COMPREHENSIVE GROUND WATER MONITORING  
EVALUATION  
OF  
AMERICAN STEEL FOUNDRIES  
MAHONING COUNTY, OHIO

OHD017497587

OHIO ENVIRONMENTAL PROTECTION AGENCY

MARCH 29, 1995

APPROXIMATE LOCATIONS OF THE GROUND WATER MONITOR WELLS

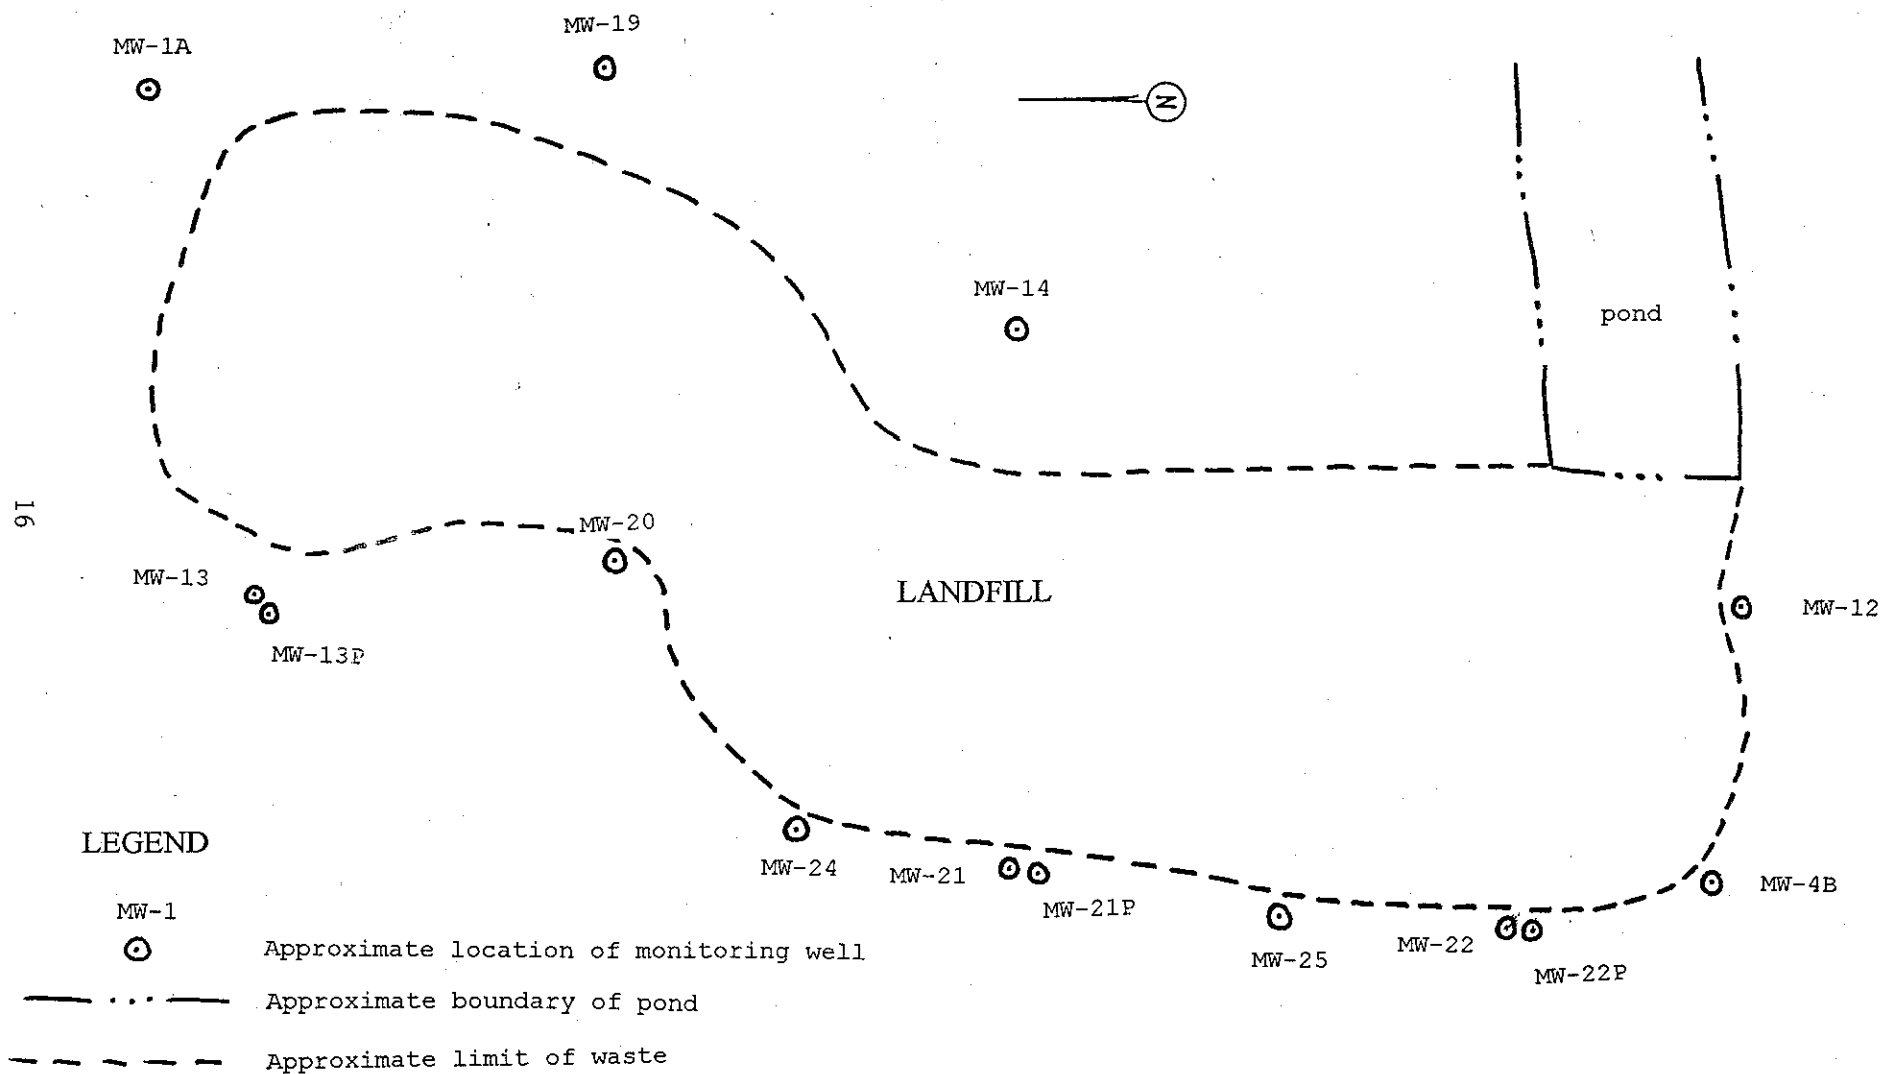
The fifteen ground water monitoring wells which make up the detection monitoring system were inspected during the CME inspection. Figure 3 depicts the approximate locations of the wells. Three wells: MW-1A, MW-14 and MW-19 are upgradient of the landfill and meet the requirements of OAC Rule 3745-65-91(A)(1). Monitor well MW-23, which is completed in the mine spoil, is sidegradient of the landfill and has been approved by the Ohio EPA for use as an upgradient well as specified in OAC Rule 3745-65-91(A)(1). Eleven Wells: MW-4B, MW-12, MW-13, MW-13P, MW-20, MW-21, MW-21P, MW-22, MW-22P, MW-24 and MW-25 are downgradient of the landfill and meet the requirements of OAC Rule 3745-65-92 (A)(2).

Figure 7  
Location of Monitor Wells,  
ASF Sebring Disposal Facility.

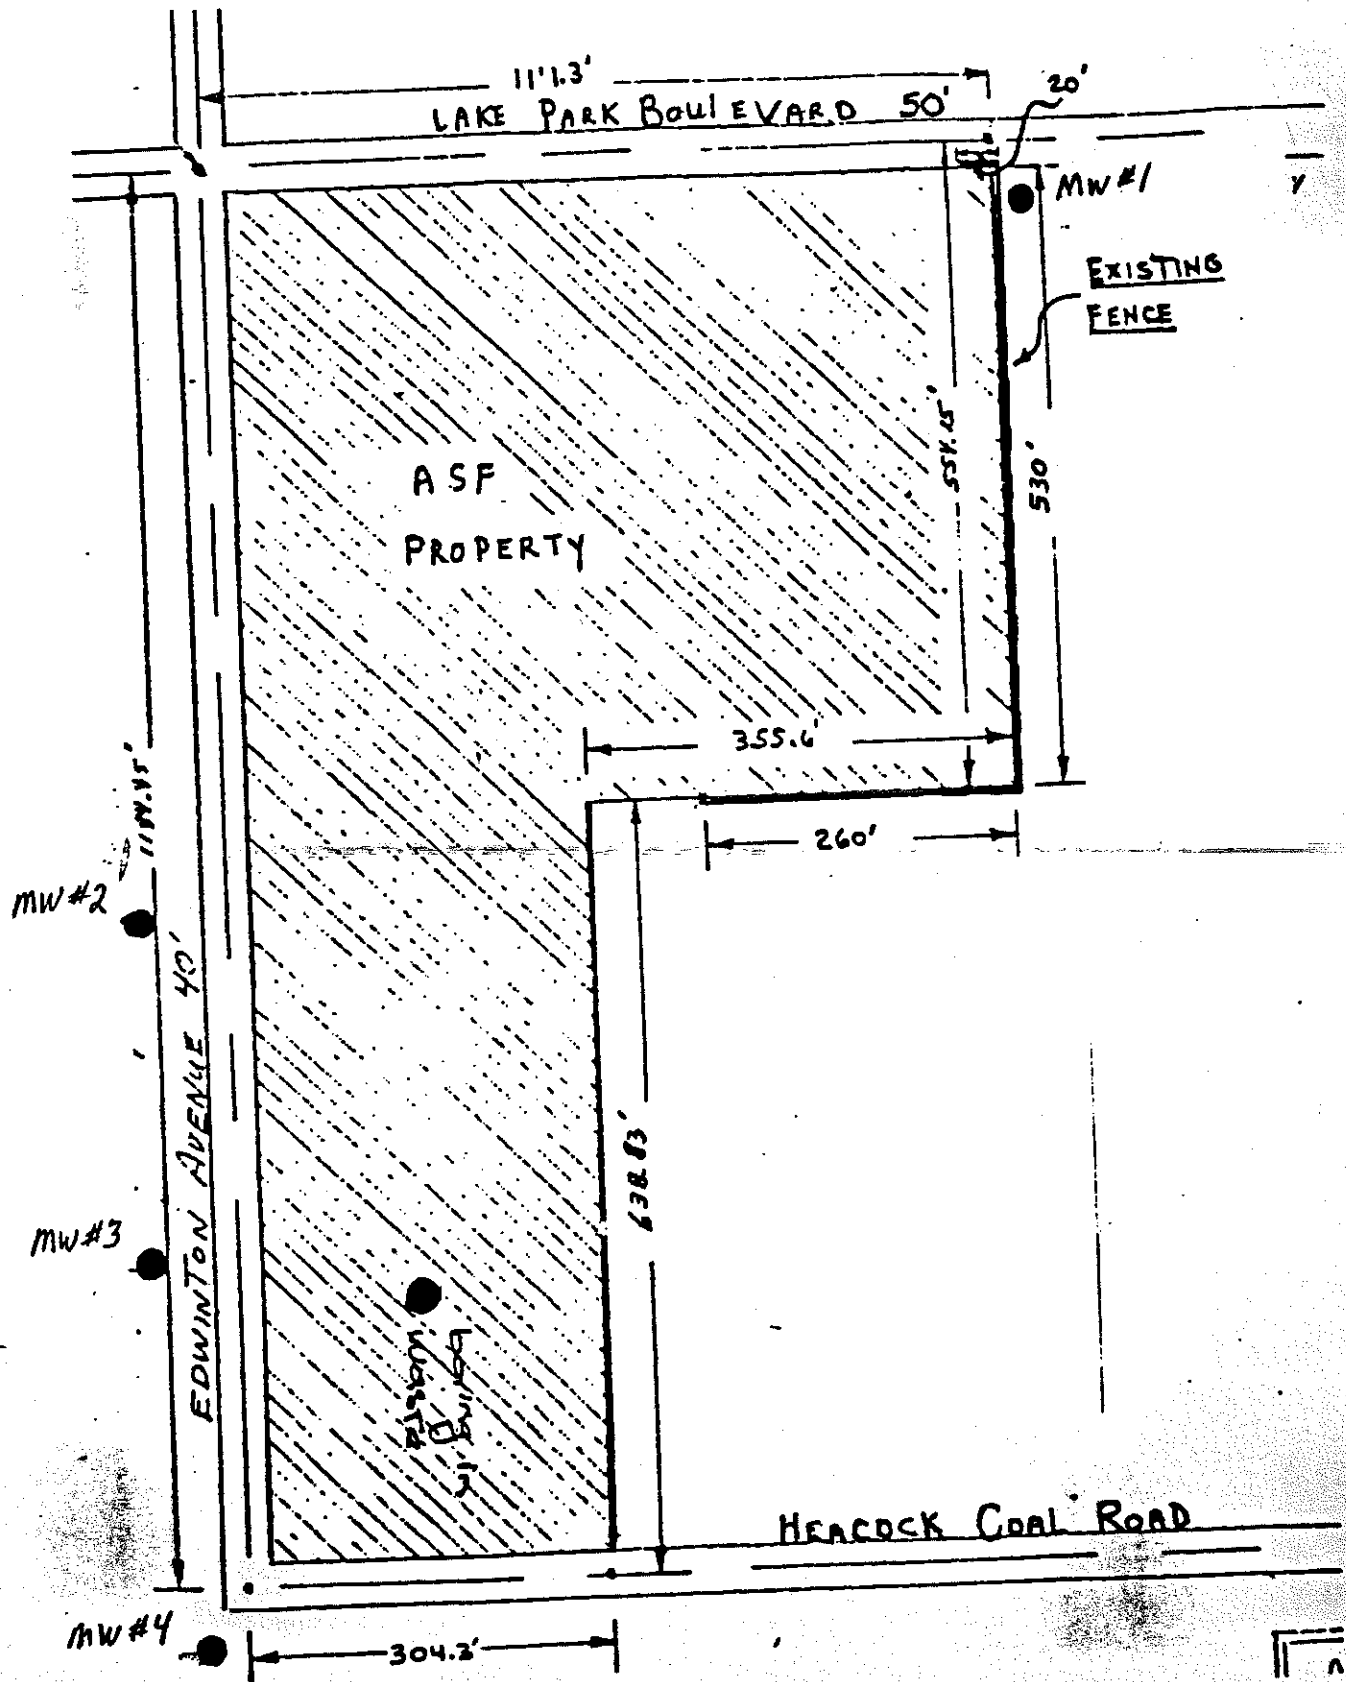
The reasoning behind the location and screening intervals of the monitor wells was not clearly stated in the Environmental Assessment Report. The aquifer system present at the facility has not been clearly defined and it is unclear as to what aquifer system these wells are intended to monitor. A preliminary report entitled, "Design of Foundry Waste Disposal, Lake Park Road Project, Alliance, Ohio" indicates that the locations of upgradient versus downgradient well locations was based upon the site topography and regional surface drainage patterns. These locations, however, were not verified by static water level measurements or water table/potentiometric surface maps and no mention was made of the aquifer system these wells were designed to monitor. Vertical screen intervals were simply set to be in the first water level below the waste. This rationale for location of screening intervals is vague and does not appear to be an appropriate method to define and monitor the uppermost aquifer system beneath the facility. ✓

Monitor well #1 was placed at the northeast corner of the site. This well is the only well which is screened within bedrock. The screened interval of monitor well #1 was set within the interval ranging from 1073.20 - 1068.20 feet elevation within bedrock in a zone of siltstones interspersed with shale. This interval lies approximately thirty (30) feet above the level of the pit floor/bottom and from three (3) to seventeen (17) feet above the screened intervals of the stated downgradient wells. According to Bowser-Morner consultants, this well is upgradient from the ASF facility.
